SITE SUPPLEMENTAL INSTRUCTION

PROJECT: Forestside Estates
Attmar & Palleschi Drive
Brampton, ON

SITE SI NO. M-7

PURPOSE: To revise make-up air risers to suit space requirements & City Permits comments.

DRAWN MC	CHECKED LM	SCALE 1:50
DATE MAY, 2019	PROJECT 18-017	DRAWING M-9
		OF -

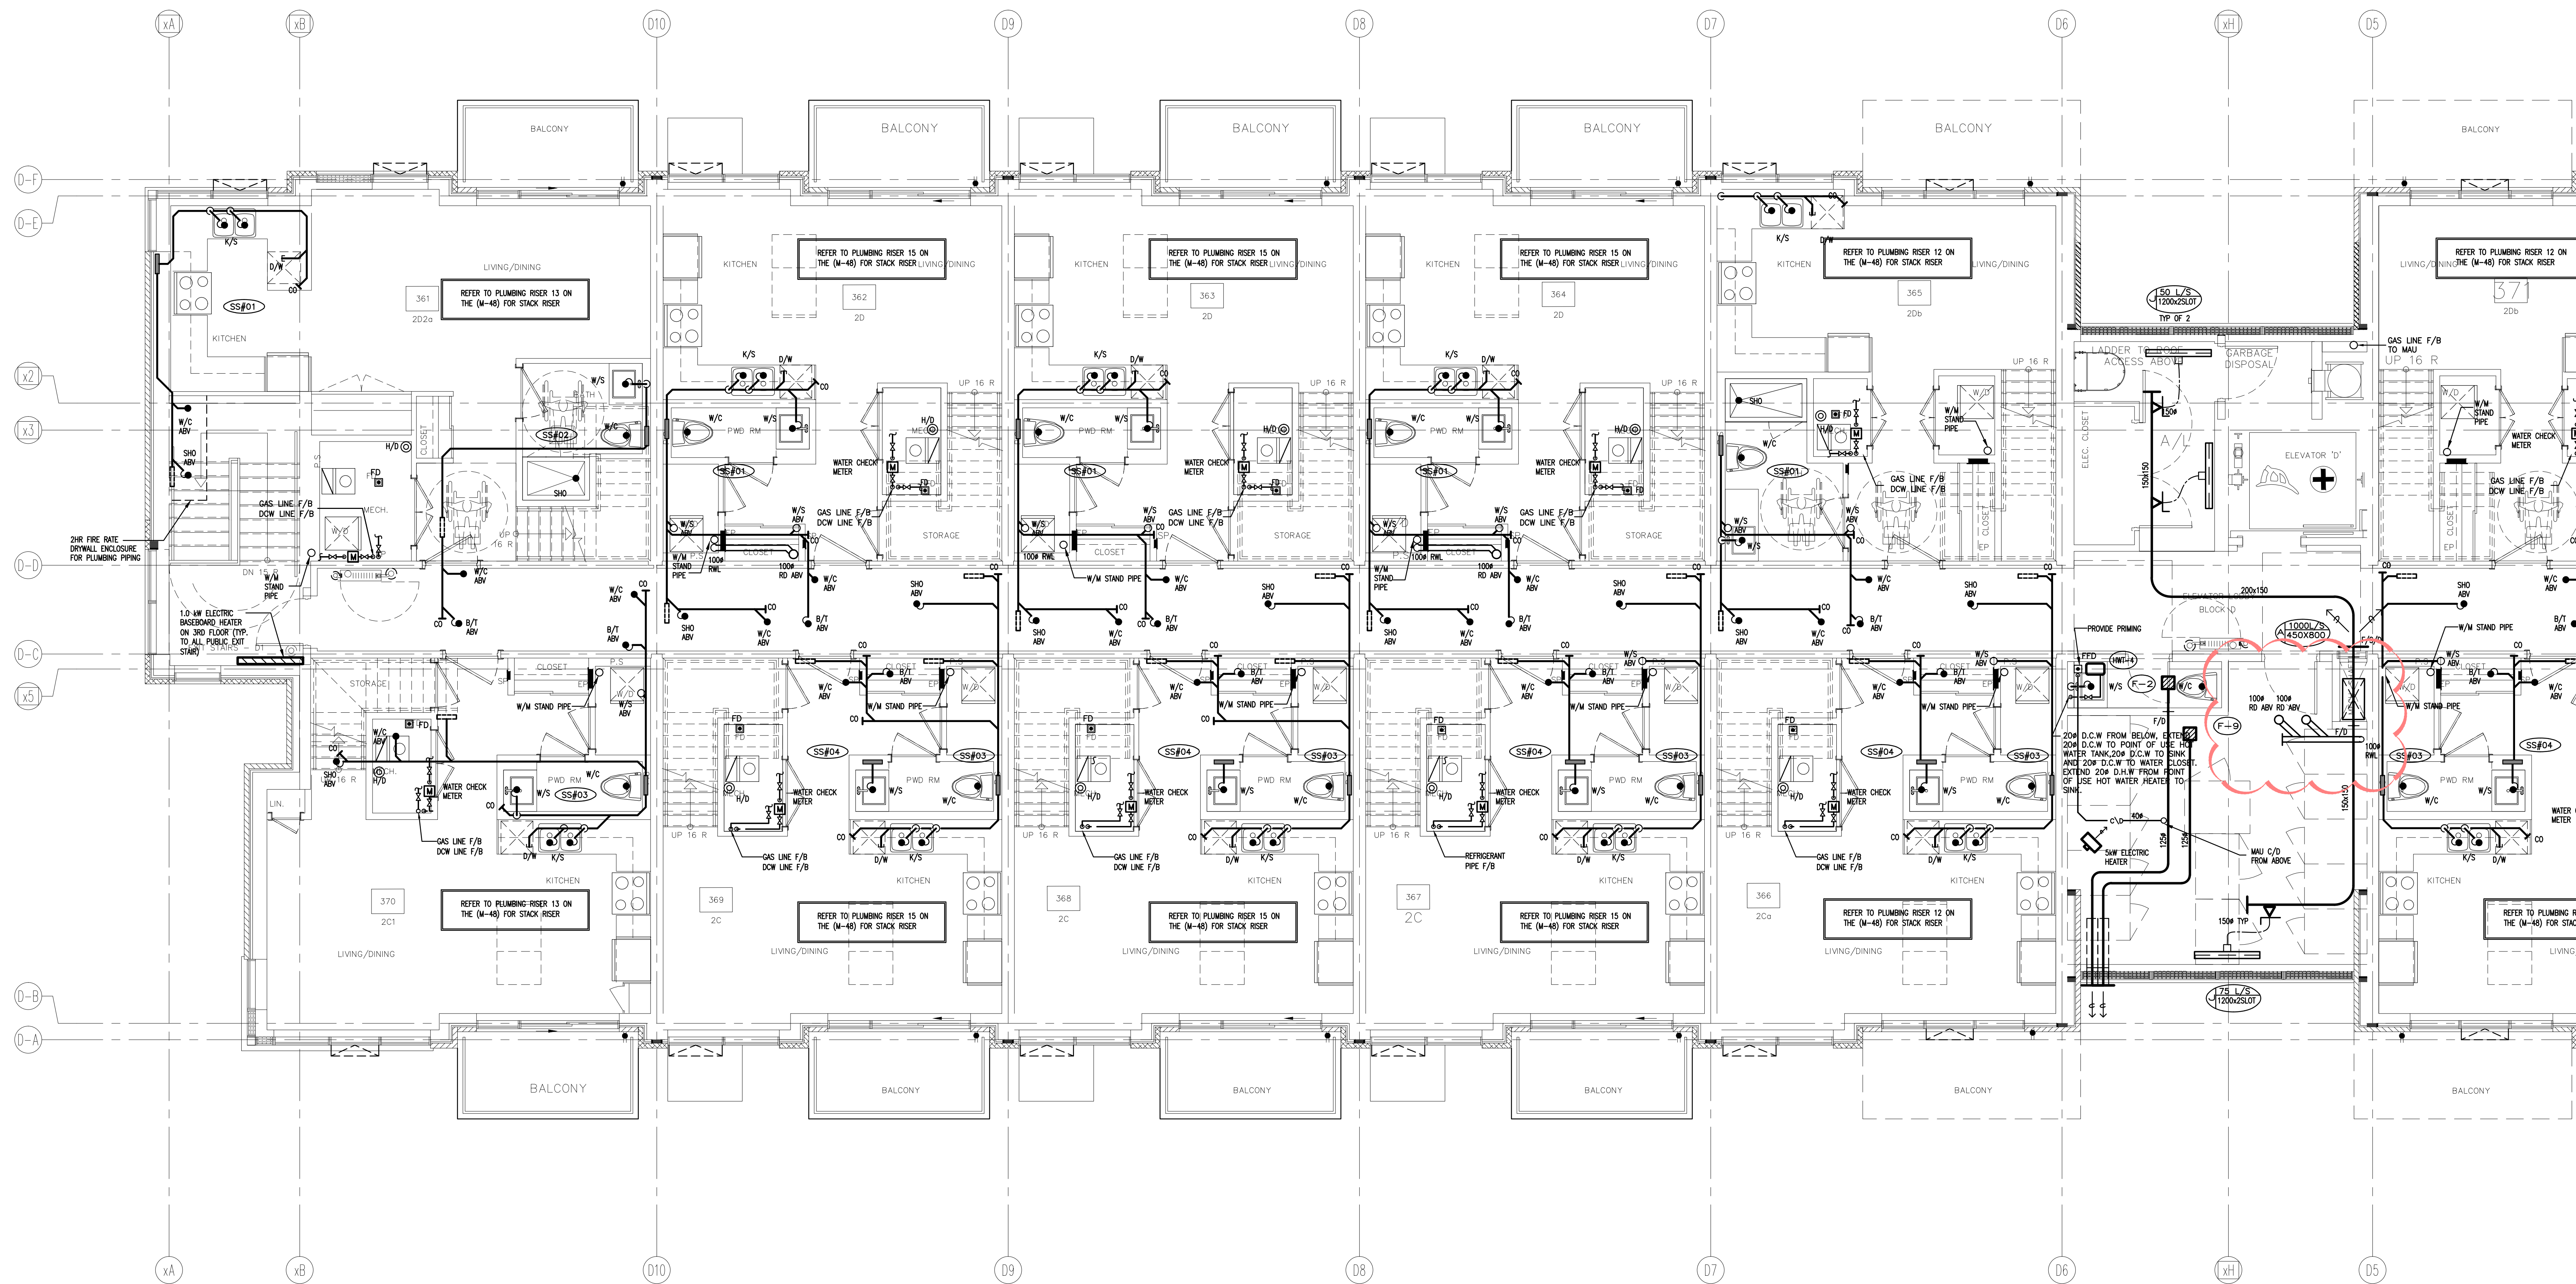
- 4.1 Relocate: Make-up air riser.
Locate make-up air riser 600mm.
Back from face of corridor wall.
- 4.2 Relocate: RWL.

DRAWN MC	CHECKED LM	SCALE 1:50
DATE MAY, 2019	PROJECT 18-017	DRAWING M-11A
		OF

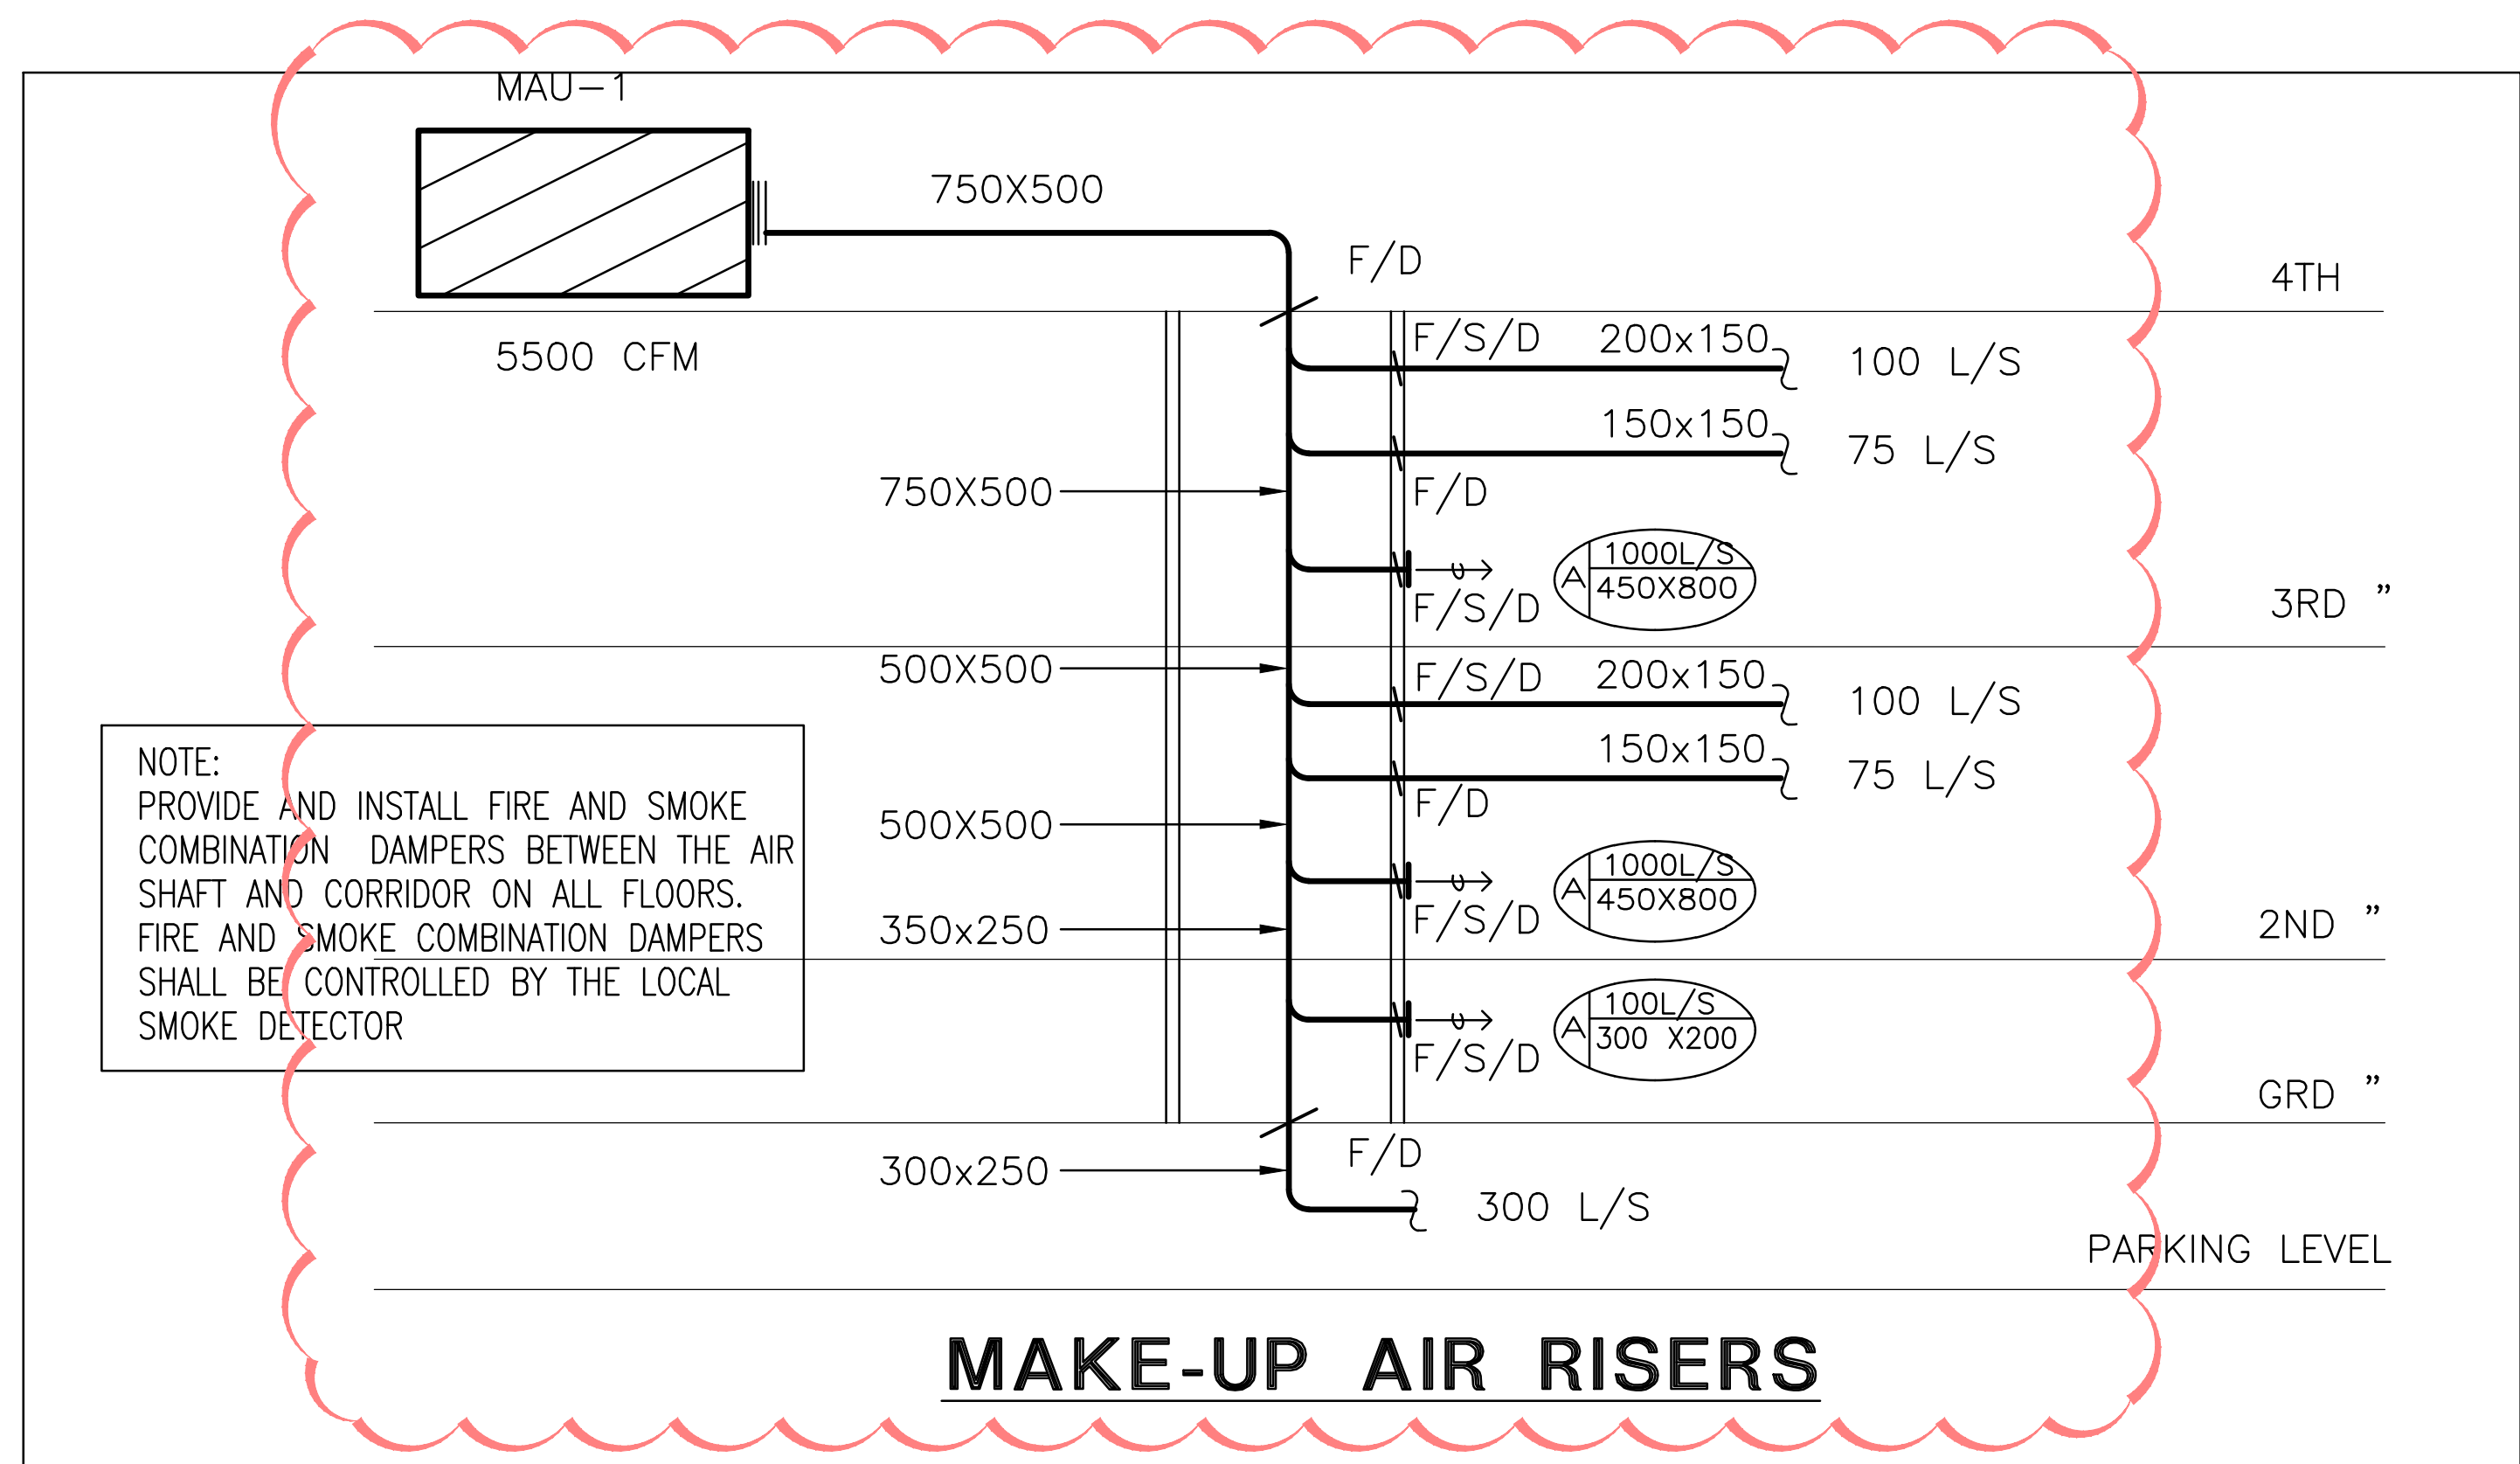
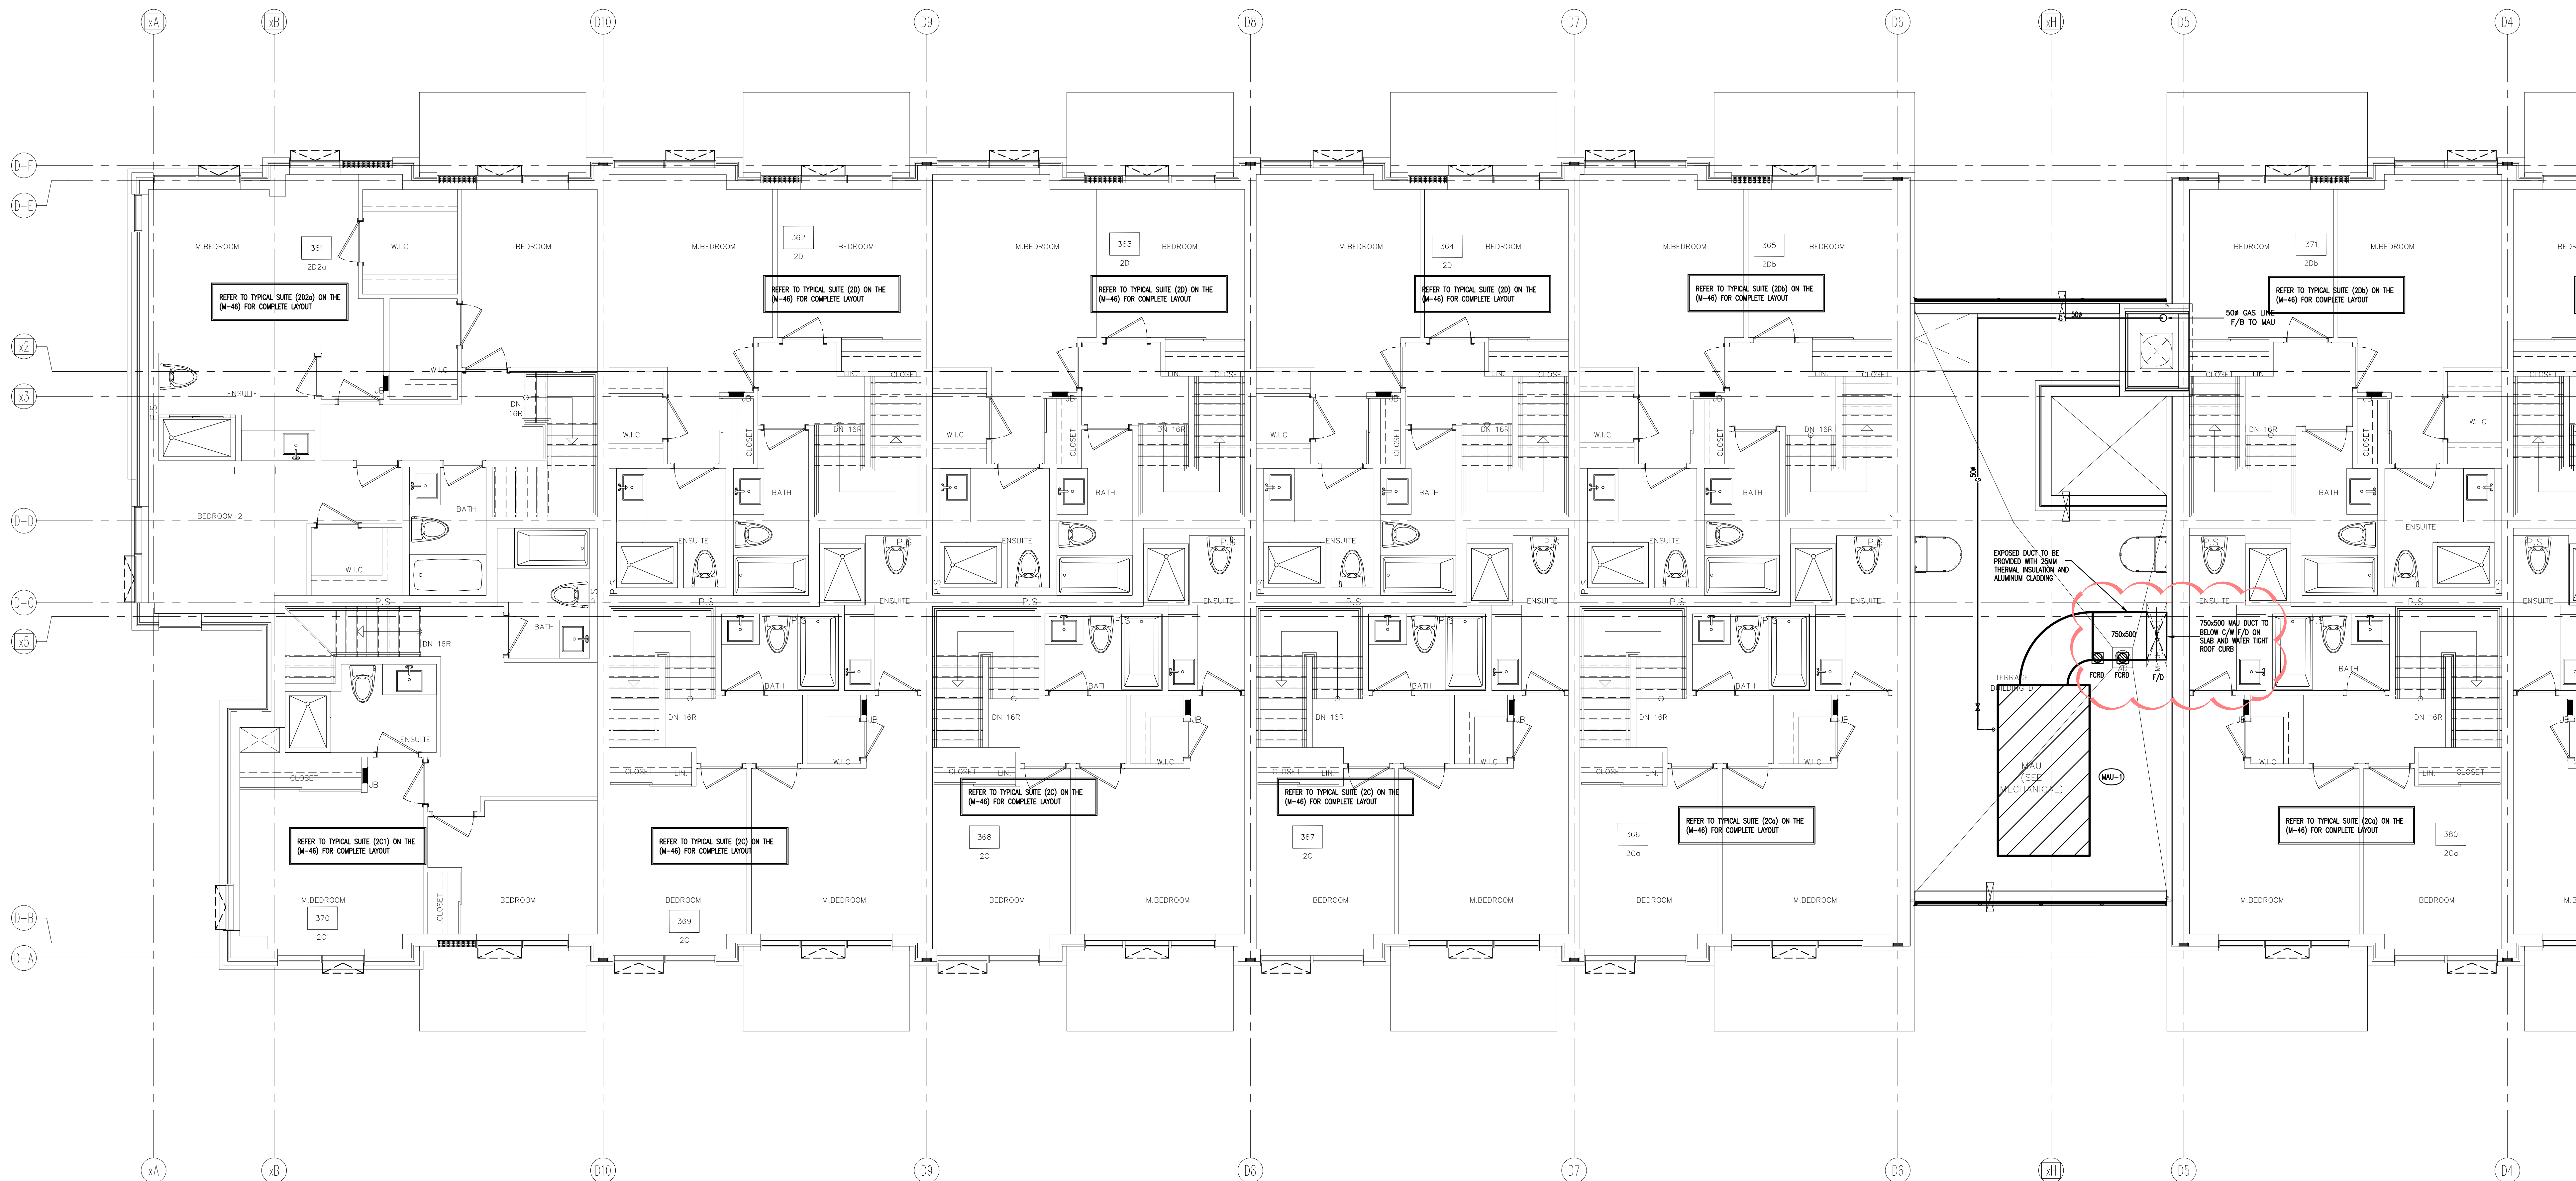
5.1 Clarify: Make-up air duct size.

5.2 Clarify: Make-up air riser diagram.
